**A. ADMINISTRATIVE REPORT & DECISION**

**Project Name:**                          Mead Short Plat

**File Number:**                            LUA16-000138, SHPL-A, MOD

Exhibit 2

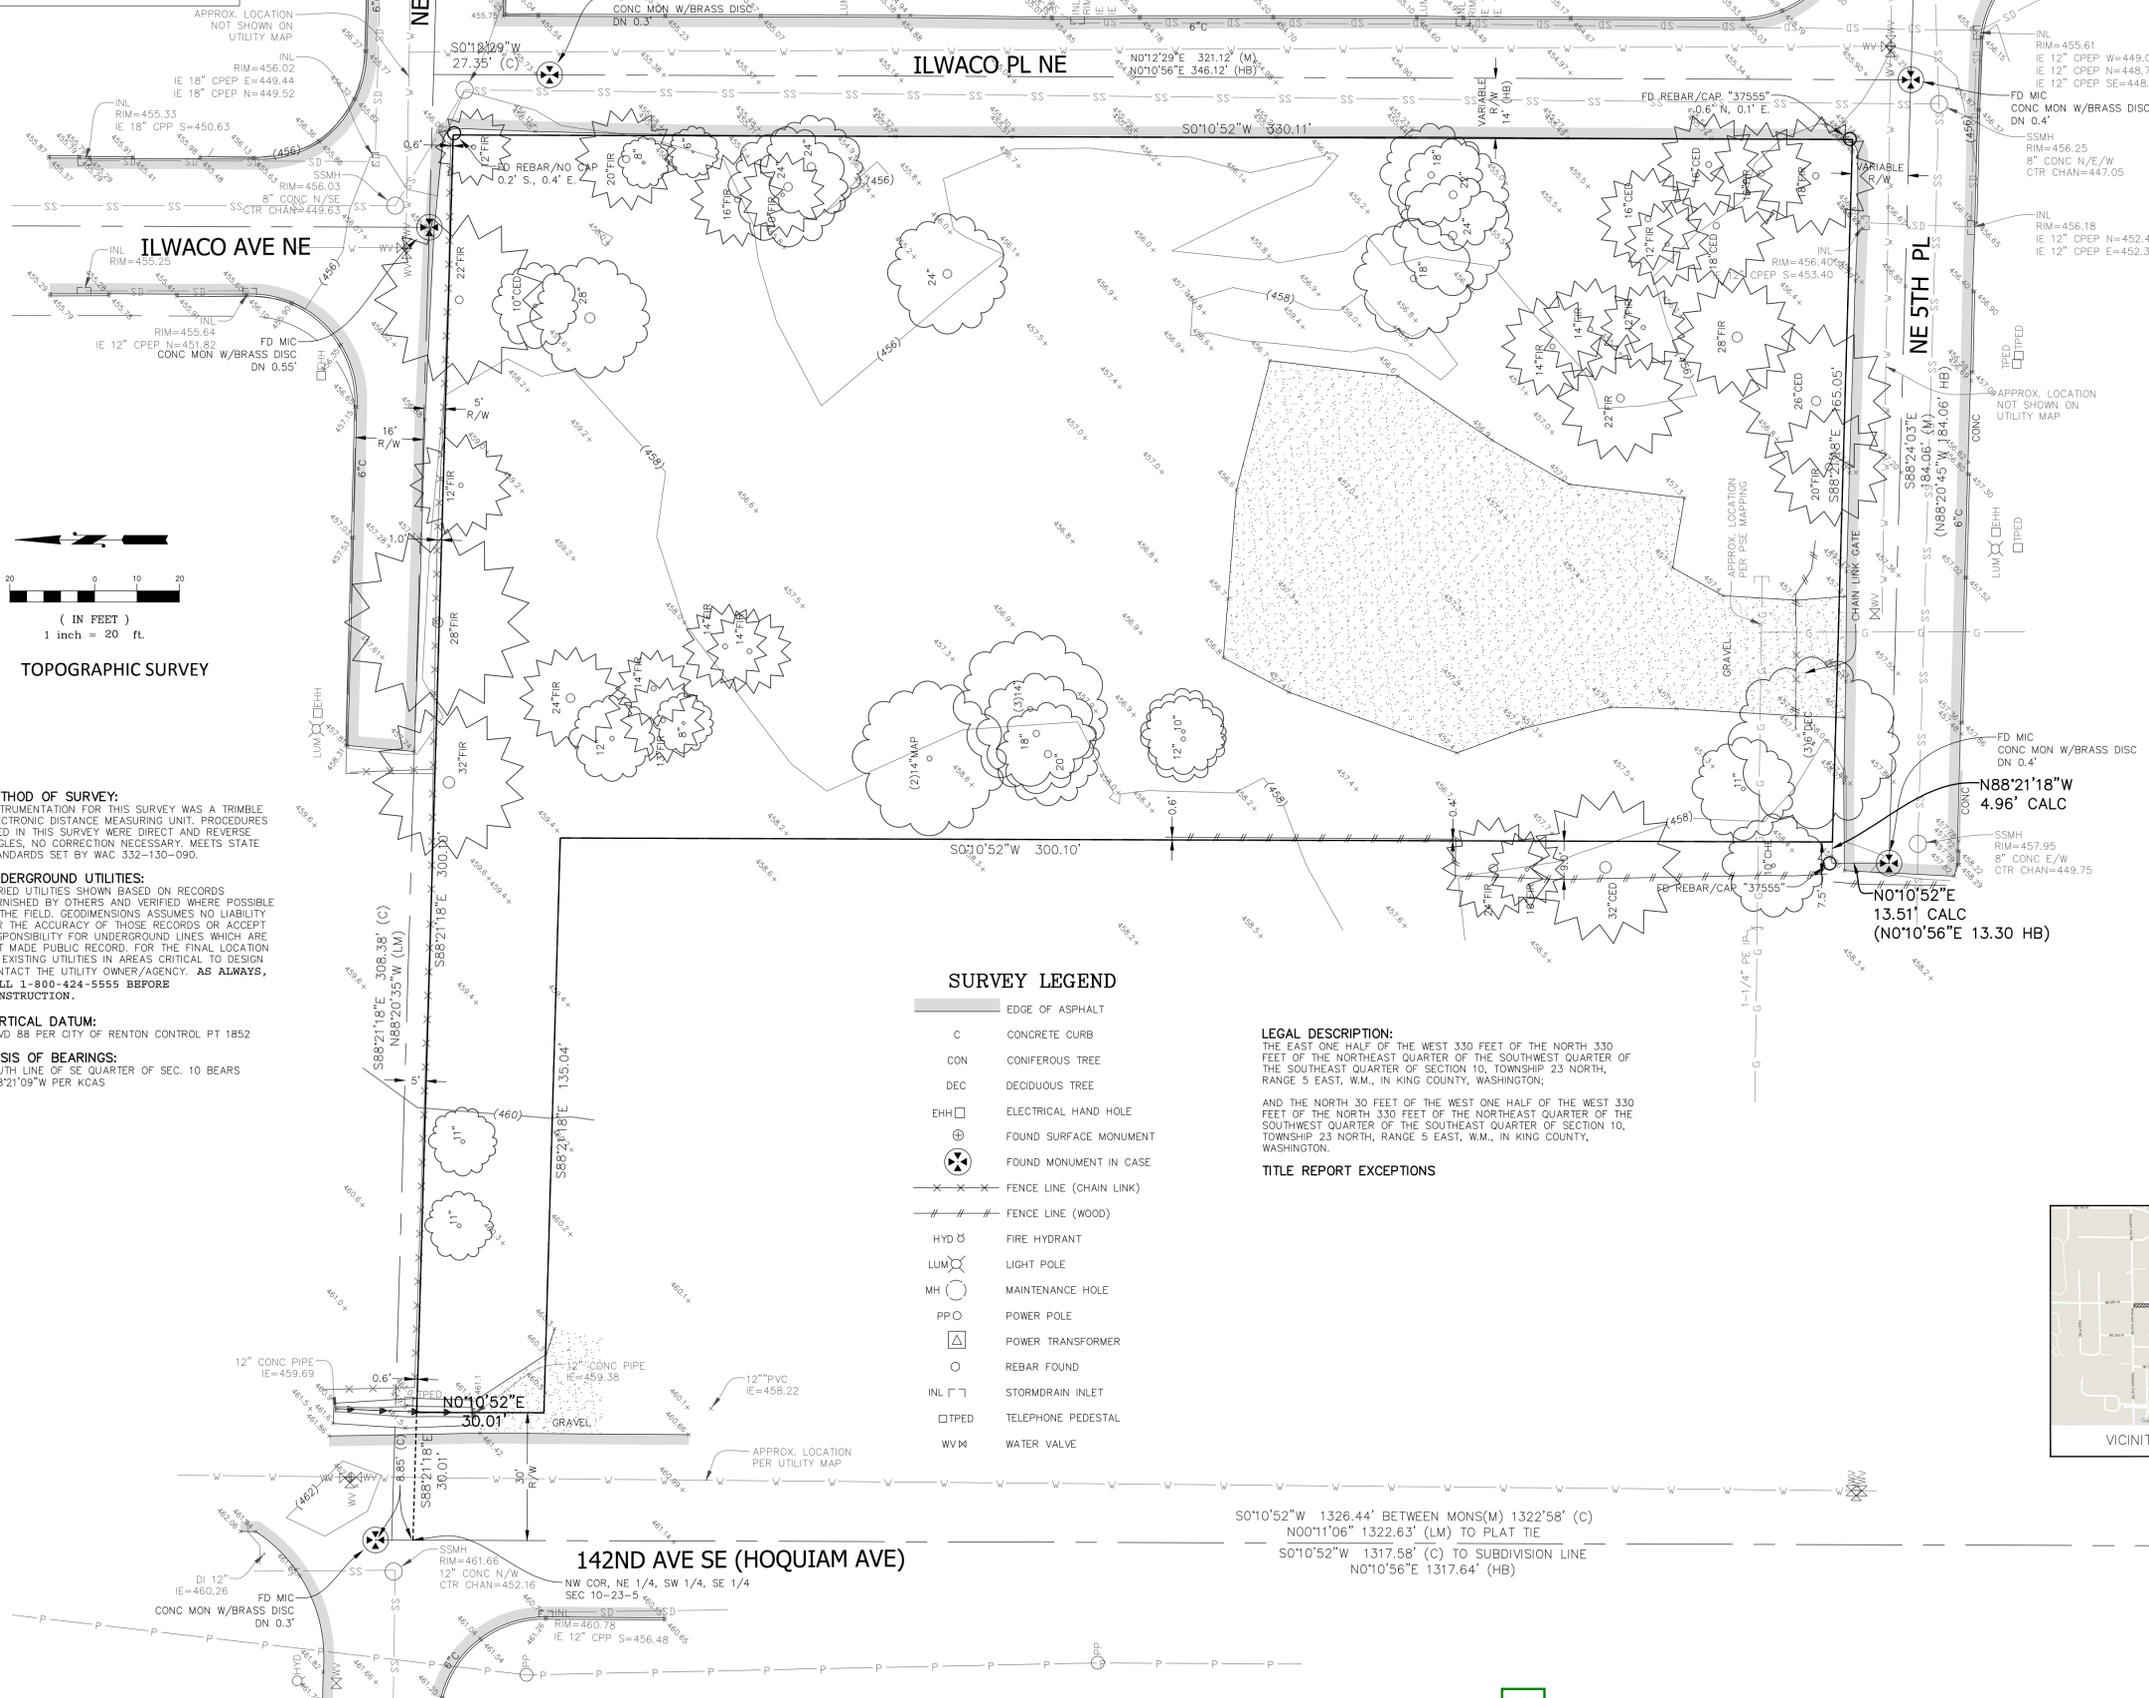
Basis of Bearing as shown is unclear on Sheet 1 of the Preliminary Short Plat.

Title Report Schedule B #9 Easement 347794 is not shown on boundary survey and a copy is not provided in the submittal package.  
Please provide.

MEAD SHORT PLAT  
TUSCANY CONSTRUCTION, LLC  
STREET WIDENING PLAN  
LUA16-000138

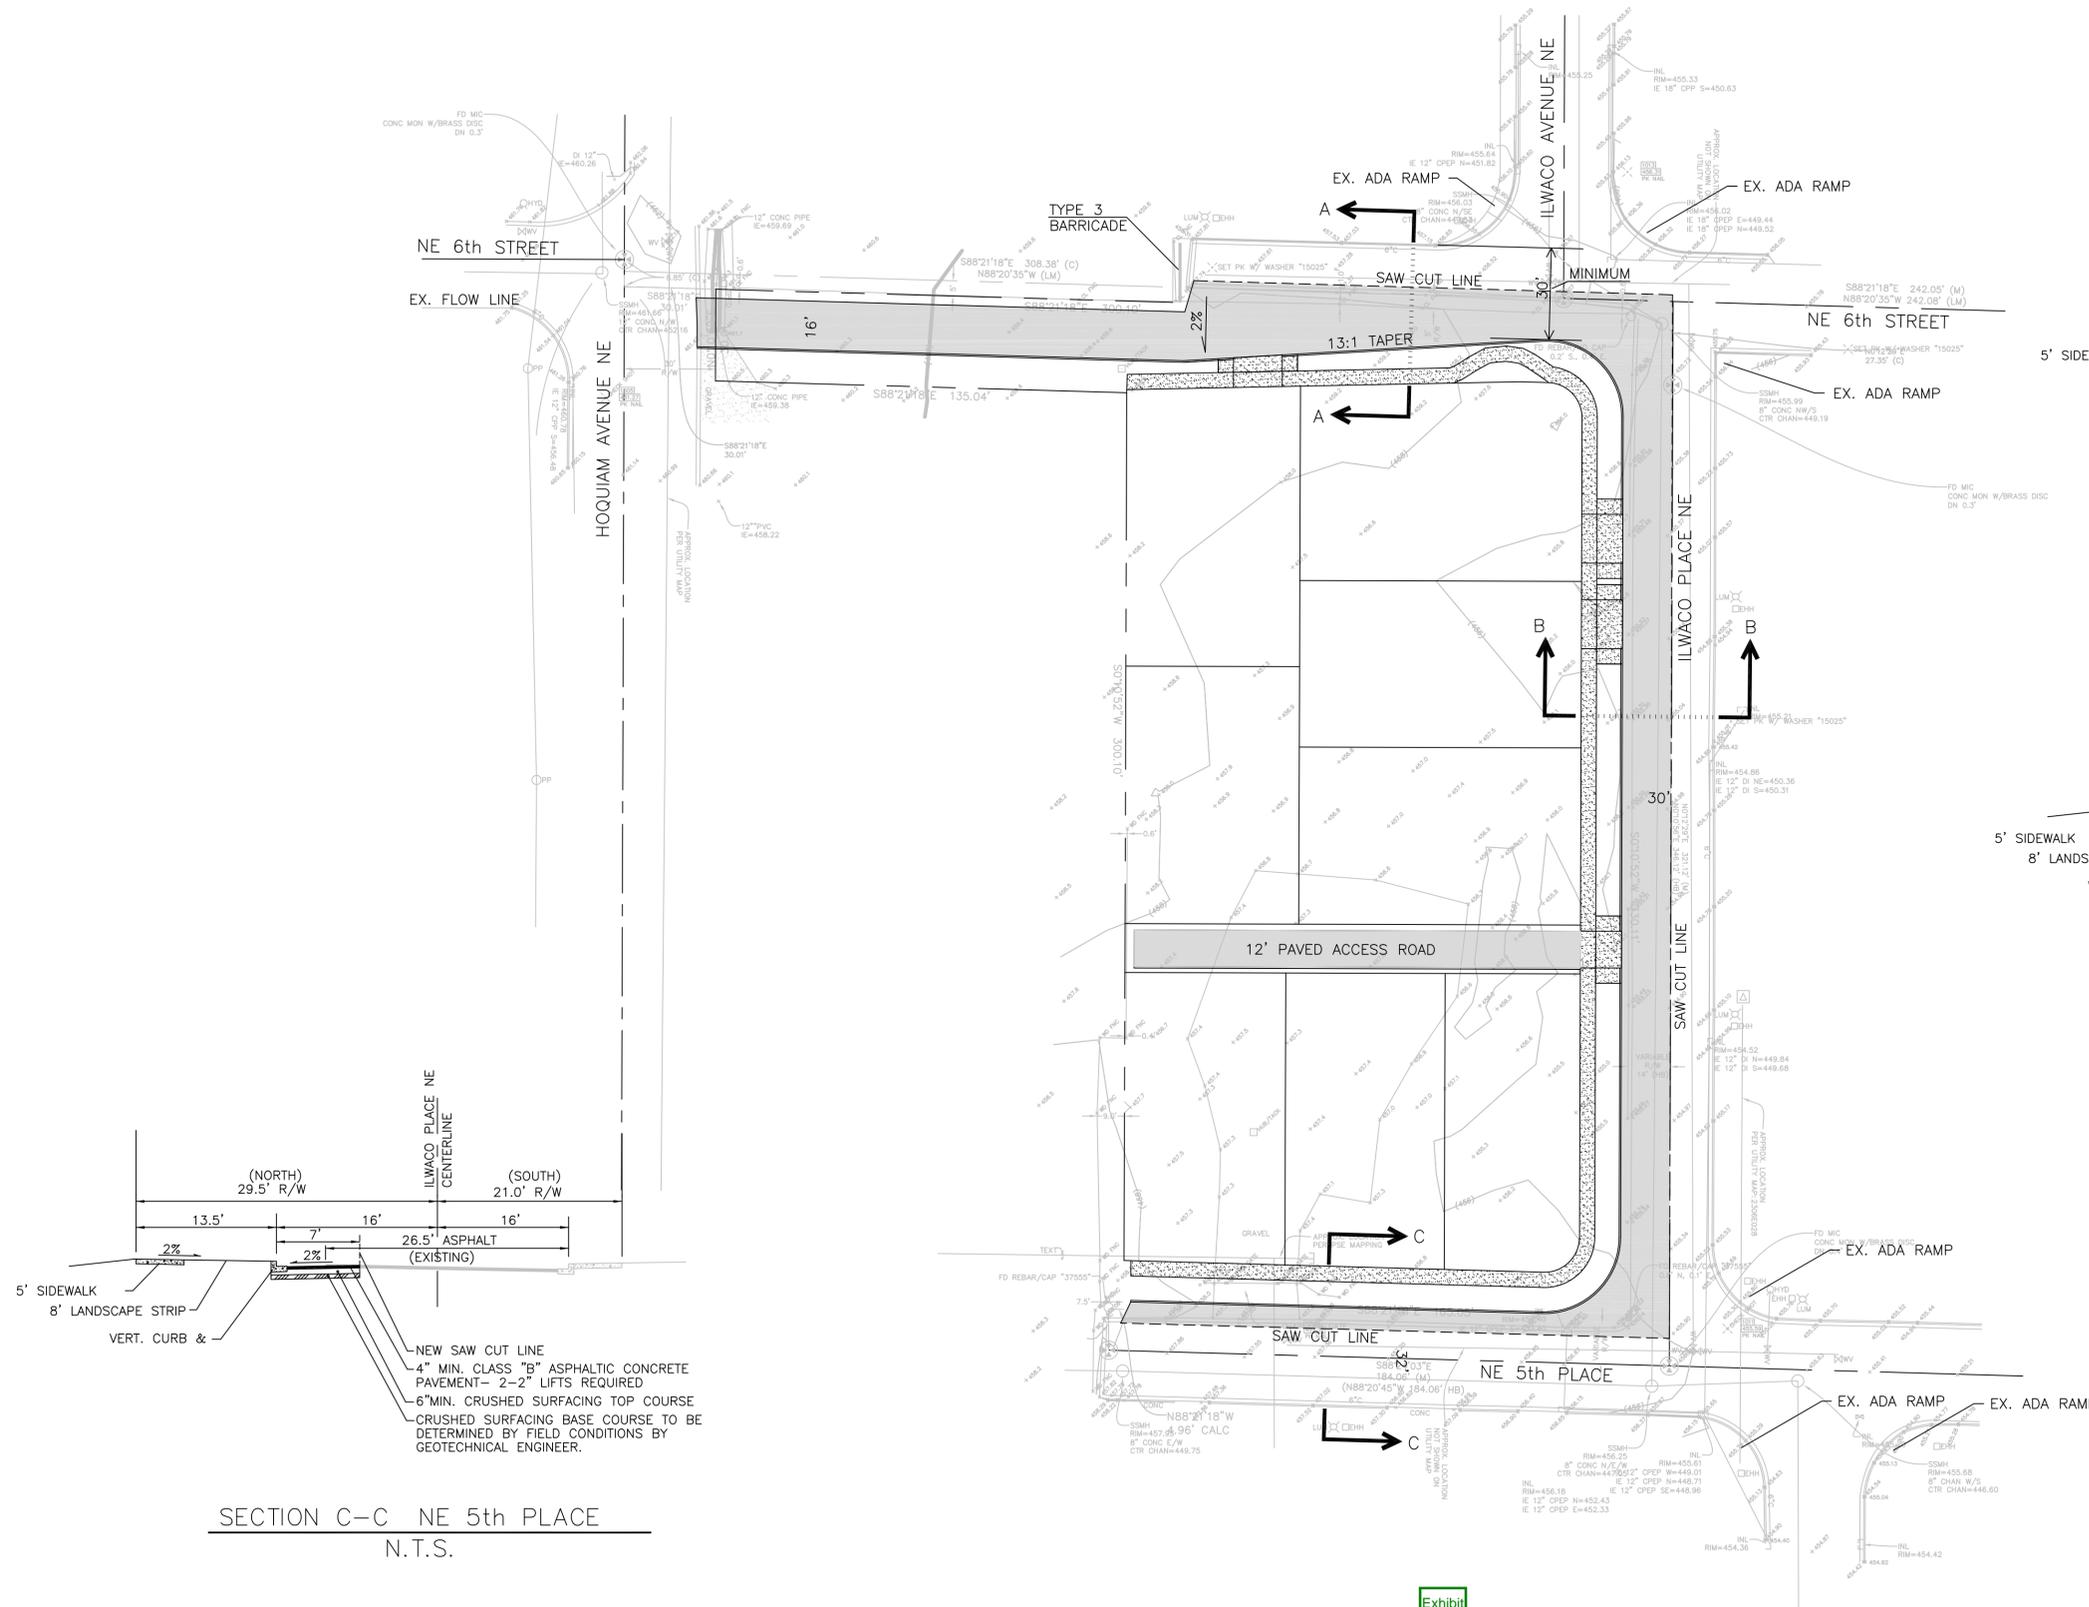
- The applicant submitted a formal modification request dated February 13, 2016 regarding the street standard for the extension on NE 6th Street in the dedicated right of way to Hoquiam Avenue NE. City staff is recommending denial of the applicant's modification request. Please see the formal response to the modification request for more information.

- The City requires a half street paved road for the extension of NE 6th Street to Hoquiam Avenue NE. The City will allow a reduction of the 20' wide pavement section to a 15' wide pavement section in order to fit within the new 30 foot dedication. In addition to the modified half street pavement section, a 0.5' curb, 8' planter, and 5' sidewalk are required. Please provide an additional street section on the street plan sheet for the extension of NE 6th Street.

- f. The City will require that the minimum design standards be met to the best of the ability at the intersection of the extension of NE 6th Street and Hoquiam Avenue NE. Please provide a design for right of way improvements for this intersection. The City will work with the developer as needed to provide design guidance.

3. Appropriate transitions for the curb, sidewalk, and roadway will need to be designed and incorporated into the final street plans.
4. Please label curb return radius at the corner of NE 6th Street and Ilwaco Place NE and at the corner of NE 5th Place and Ilwaco Place NE. Right of way dedication at corner lots appears to be adequate to accommodate the required turning radius, curb, 8' planter, and 5' sidewalk.

MEAD SHORT PLAT  
 TUSCANY CONSTRUCTION, LLC  
 DRAINAGE PLAN  
 LUA16-000138

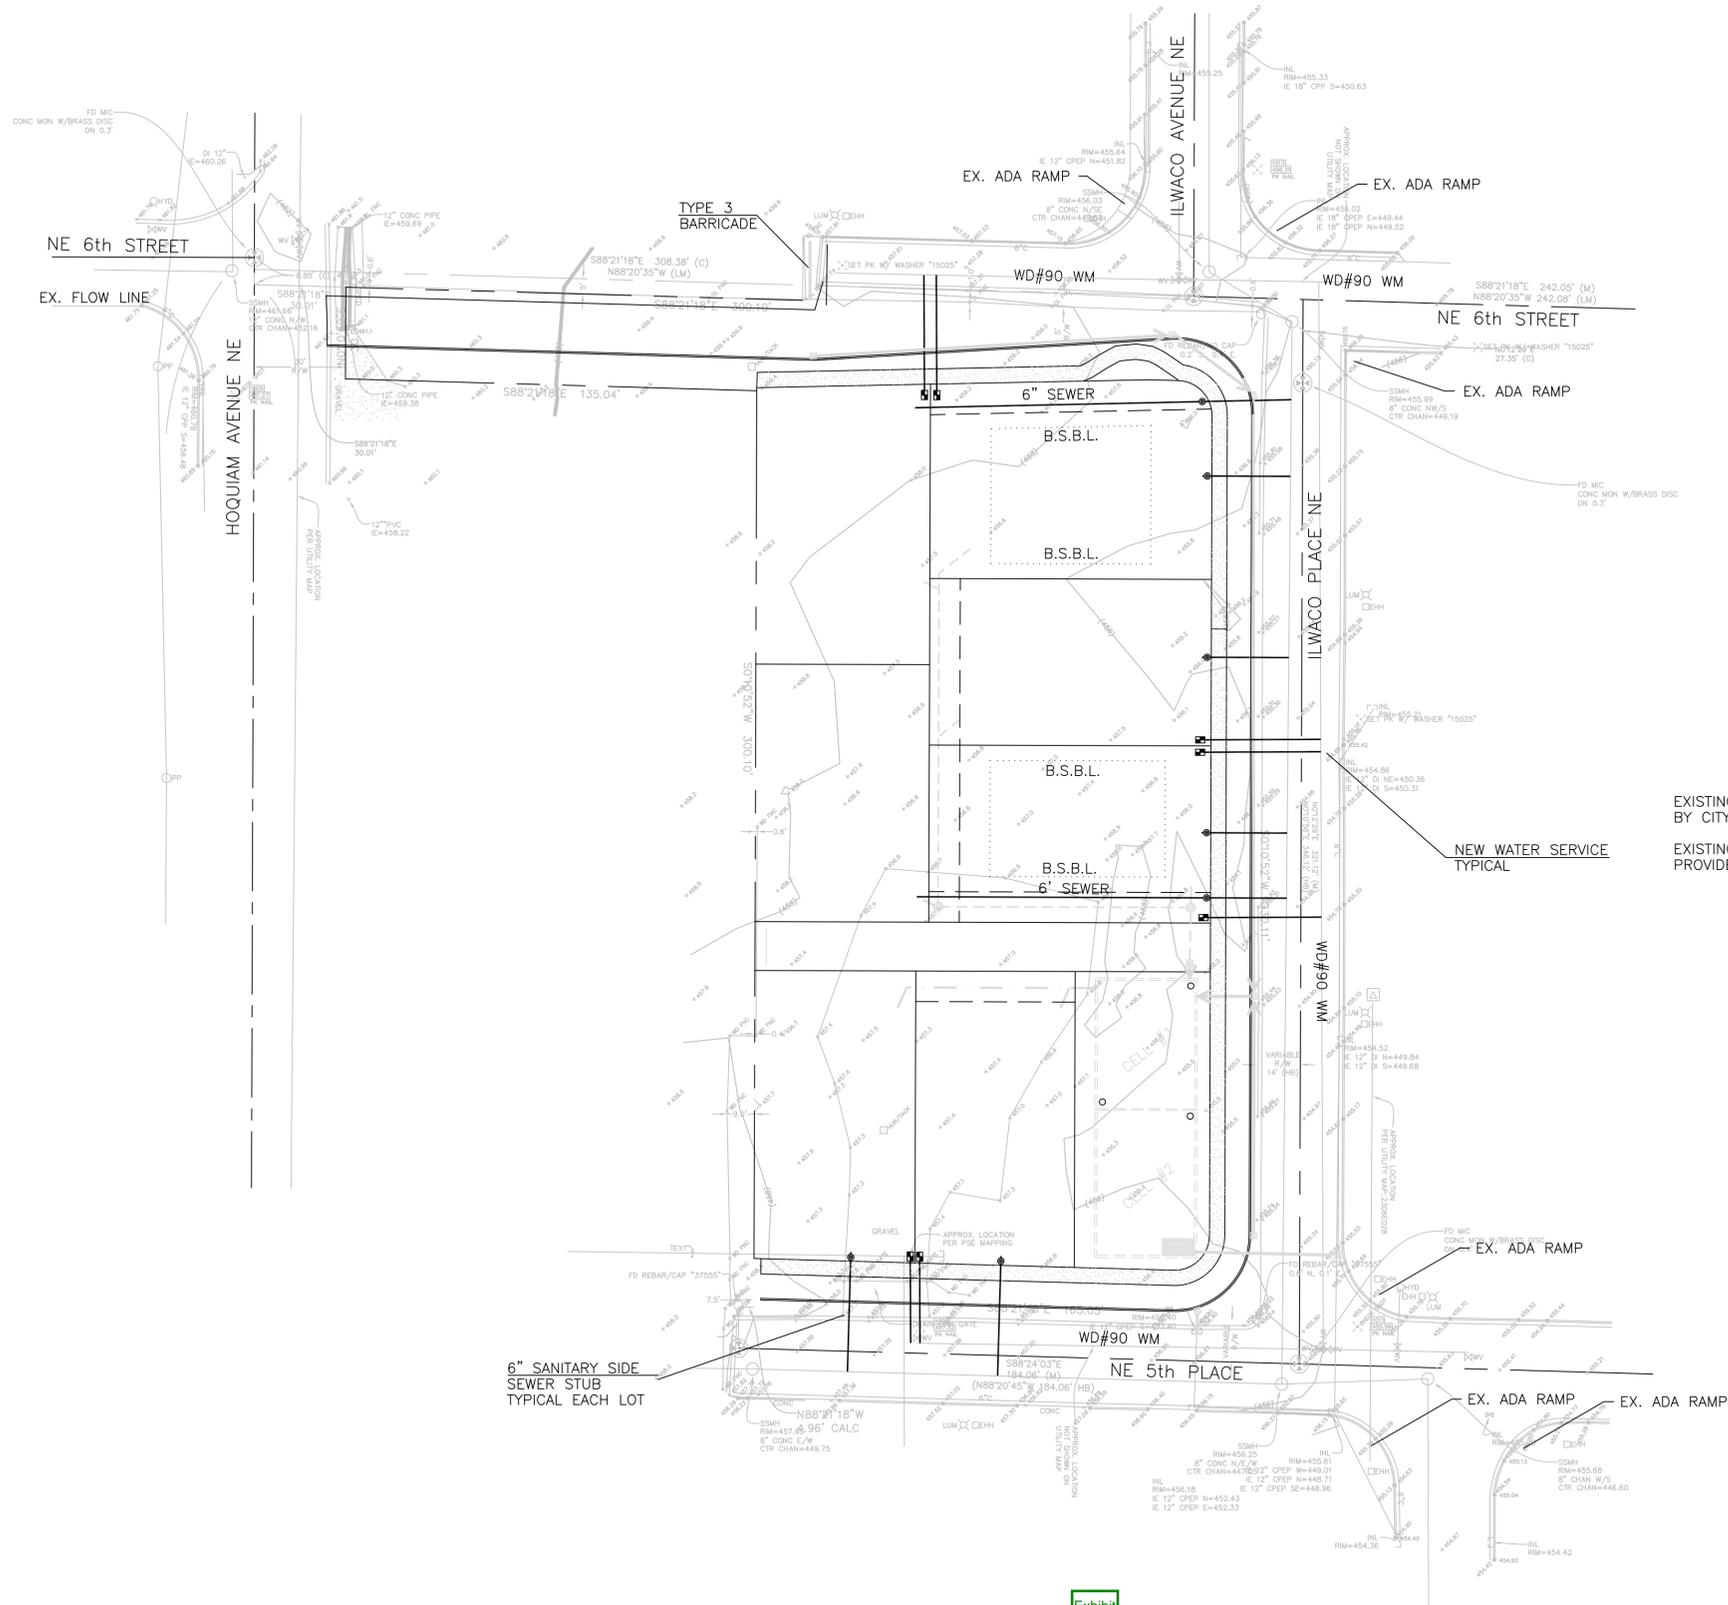
- A Preliminary Drainage Plan and Technical Information Report (TIR) completed by Offe Engineers were submitted to the City on February 20, 2016. The site is approximately 1.34 acres in size and is located in the City's Flow Control Duration Standard (Forested Conditions). The site contains two Threshold Drainage Areas (TDA). The majority of the site is in the May Creek drainage basin. The panhandle/pipe stem portion of the site west of the NE 6th Street pipe stem is part of the Lower Cedar River drainage basin. The project is proposing a combination detention / wetvault design that discharges at the site's natural location to meet the City's Flow Control and Basic Water Quality standards. The proposed vault will be a public stormwater facility. Access to the vault per the City's amendments to the KCSWDM shall be provided. The project will also require individual lot Flow Control BMPs. Please section 1.2.3.3 and Section C.1.3.1 of the City amendments to the KCSWDM for Flow Control BMP requirements. All core and special requirements shall be addressed in the updated TIR.

Drainage improvements along all street frontages shall conform to the City's street standards. Storm drains should be located outside of the planter and the sidewalk. Required horizontal and vertical separation from other utilities shall be provided. Catch basins should be located at the PC and PT of curb returns where possible.

The updated drainage plan and TIR will be required as part of the utility permit submittal.
